ISCS - Feature #703

line3# 1500V

▪ 2.1.1500V触网一键停送电控件界面

图 1 程控控件-1500V 触网一键停送电

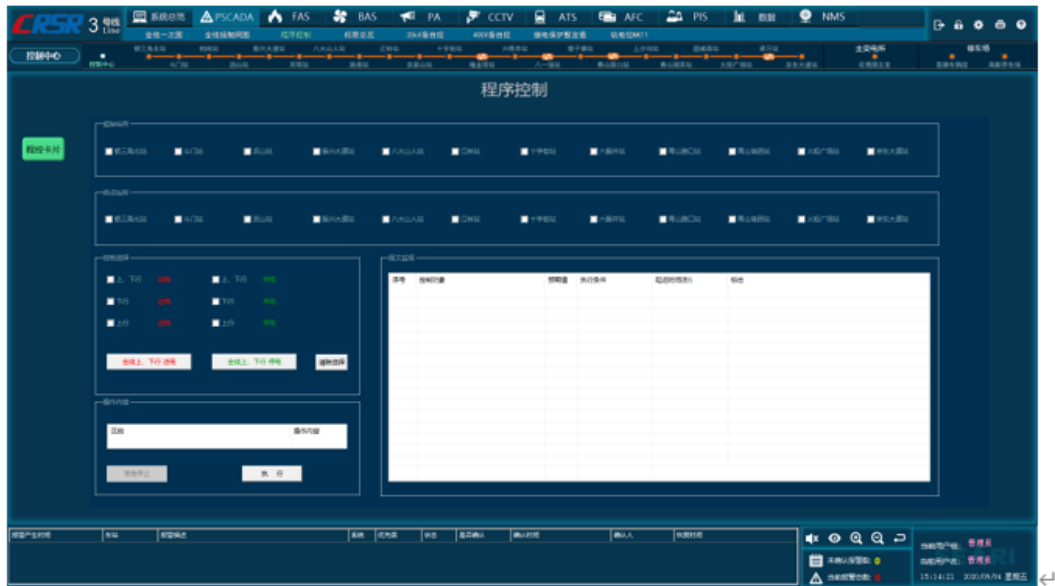
基于图 1，在报文监视区域增加时间列，时间列显示操作下发执行和操作结果反馈的时间。

在操作内容显示框中需要增加显示供电分区编号，供电分区上下行拥有不同的供电分区编号

当选择包含银三角北站进行上、下行触网停送电时，本站 211、212、213、214、215、216 六把开关及相应闸刀均动作。当选择的区域包含银三角北站，并且只选择上行或者下行时，银三角北站可以动作 3 把开关及相应闸刀。

当选择包含京东大道站进行上、下行触网停送电时，本站 211、212、213、214 四把开关及相应闸刀均动作。当选择的区域包含京东大道站，并且只选择上行或者下行时，京东大道站可以动作 2 把开关及相应闸刀。
